Regarding: LAND DEVELOPMENT - RESUBMITTAL

**MODWASH EXPNSION**

3474 WILLIAM PENN HIGHWAY, WILKINS TWP, ALLEGHENY COUNTY, PA

In response to the comments received from the municipality on April 19, 2023, for the proposed Modwash expansion located at 3474 William Penn Highway in Wilkins Township, we wish to offer the following responses in black bold text:

SHEET NO. C100

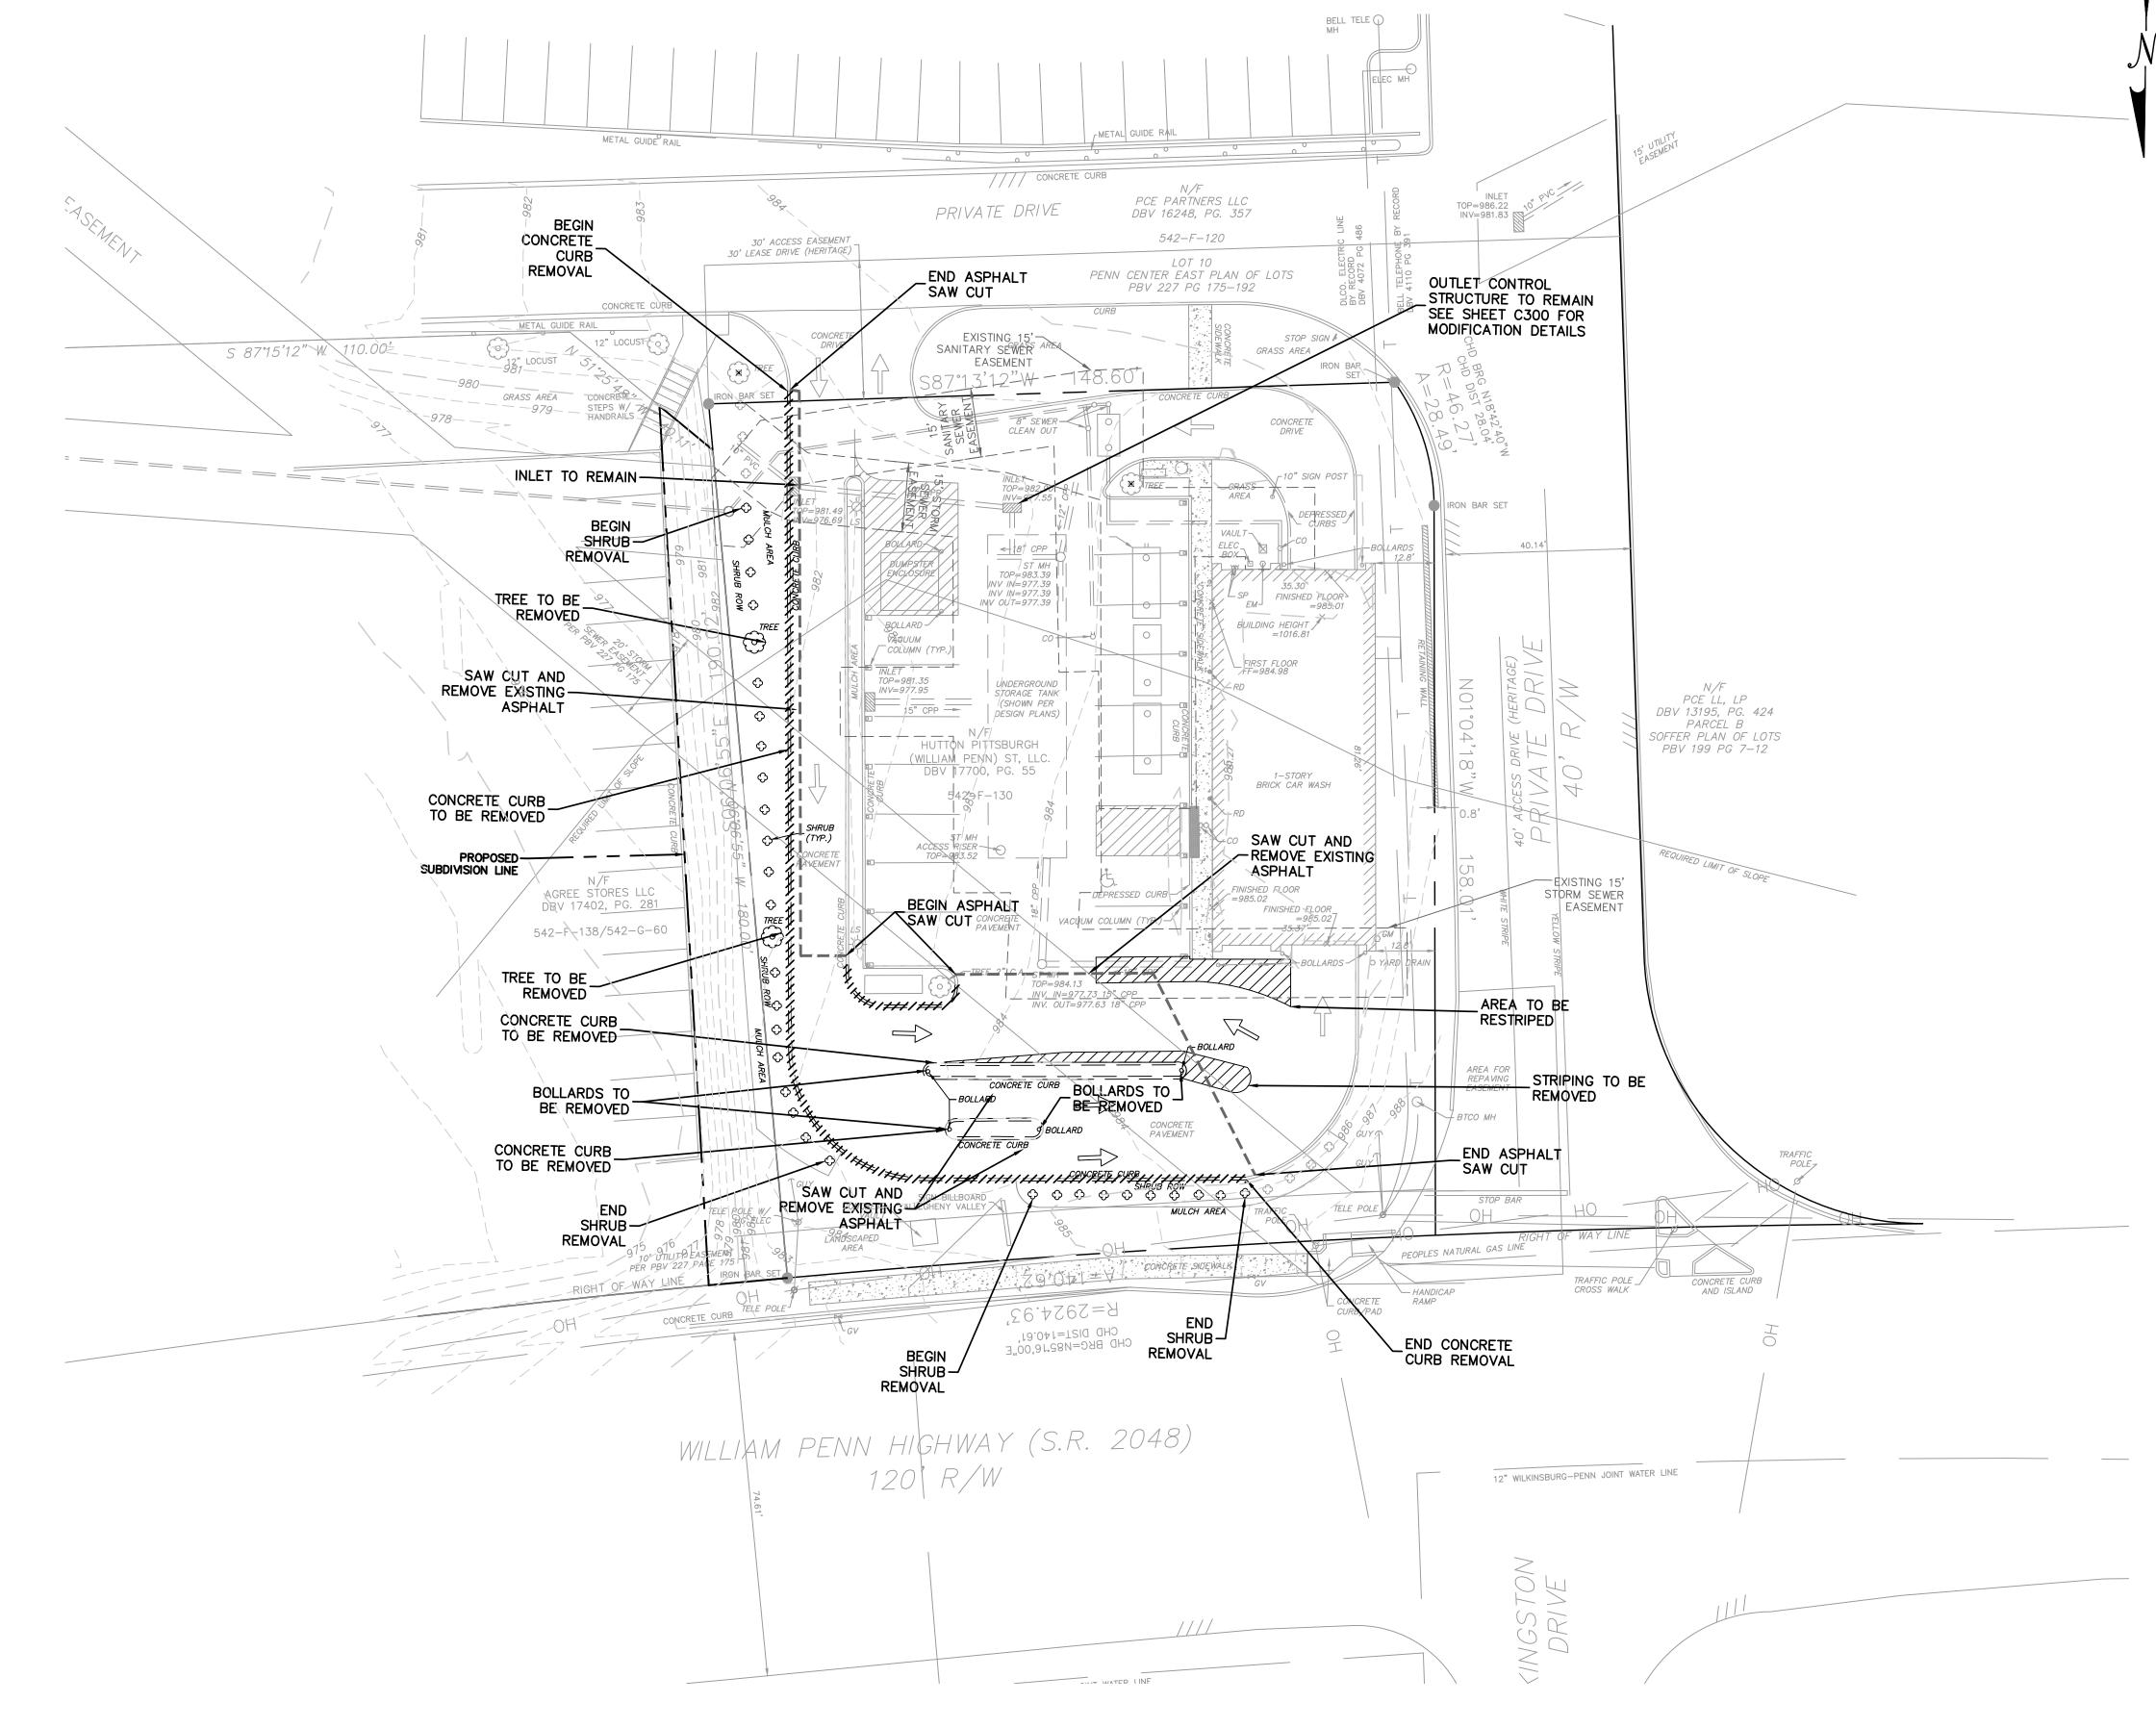
14. Tract boundaries with bearings and distances should be included in the plan set.

Response: Please refer to sheet C100 for the existing tract boundary with bearings.

SHEET NO. C701

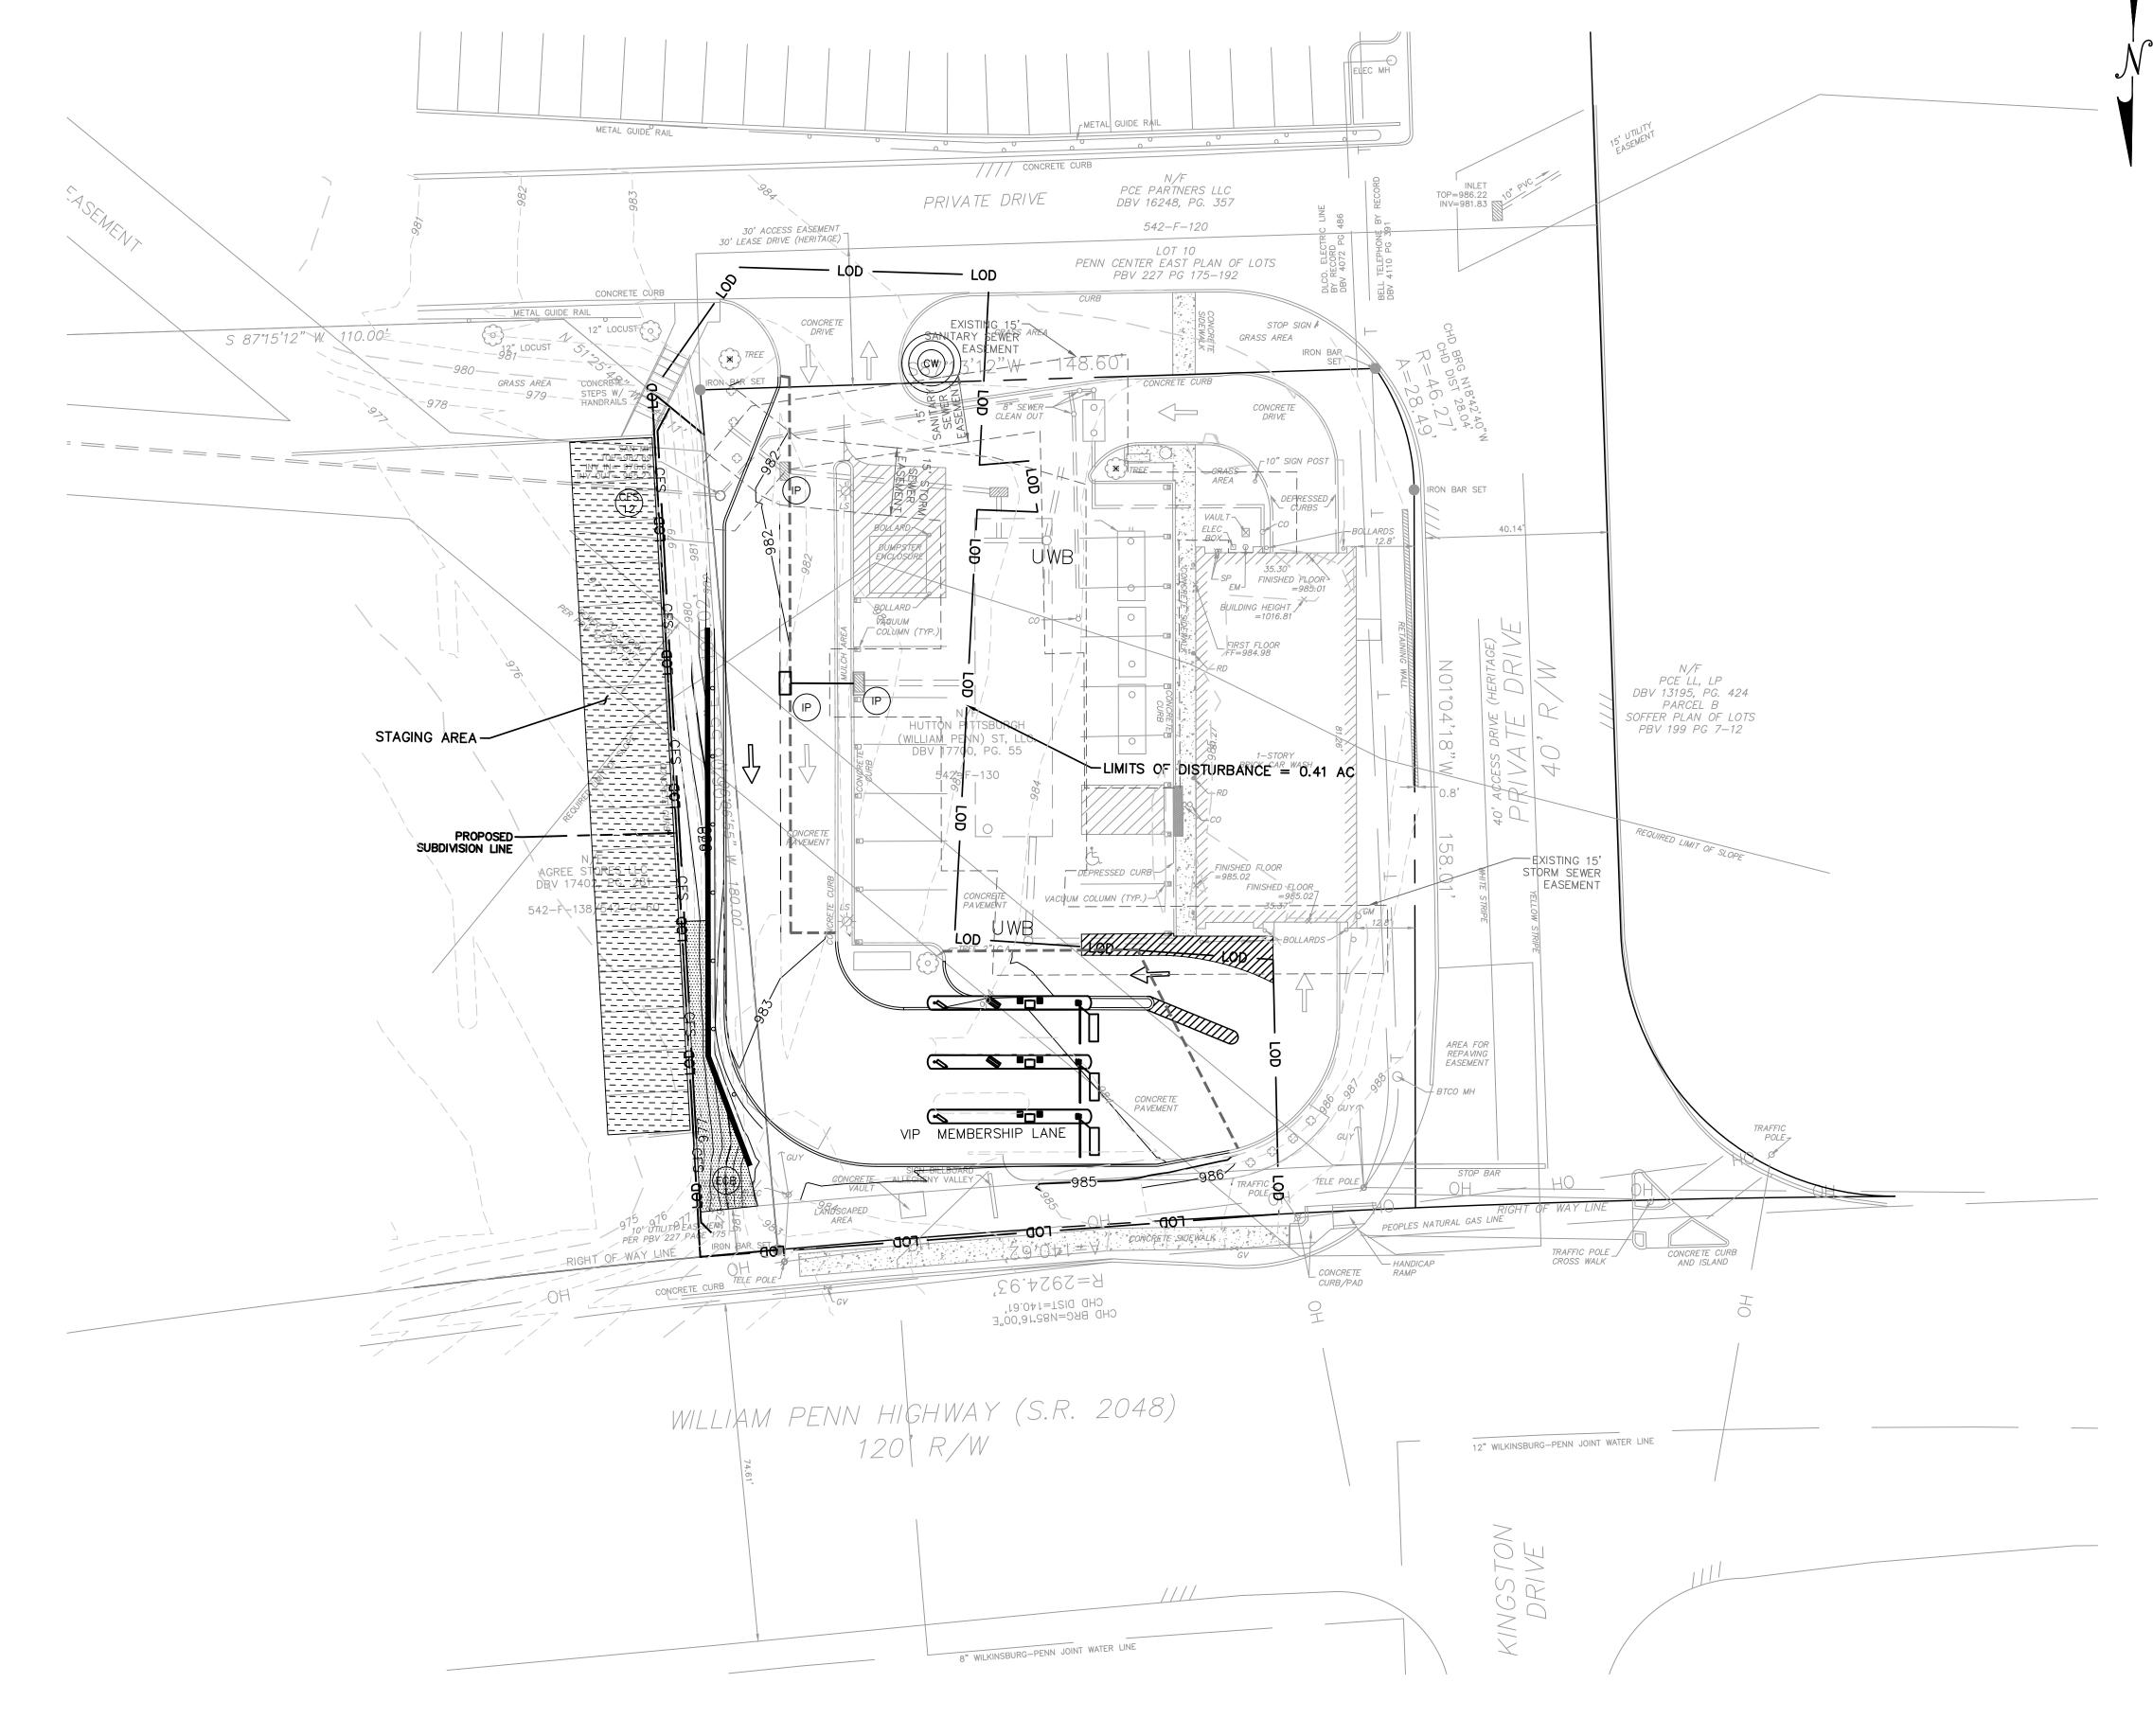
3. Similarly, the limit of disturbance areas shown on Sheet C701 is shown as 0.41 acres, please confirm.

Response: The proposed limit of disturbance for this site is 0.41 acres.

Page 23

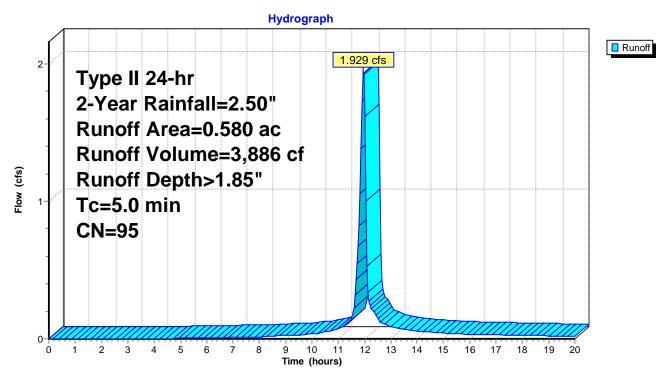
6. Device 5 on page 23 in the PCSM report is labeled as secondary routing but appears to flow through the 12-inch culvert (device 1). Please confirm whether is should be routed as primary, not secondary.

Response: Please refer to the updated PCSM report. The 12-inch culvert is listed as primary while all other orifices and weirs are listed as device 1.
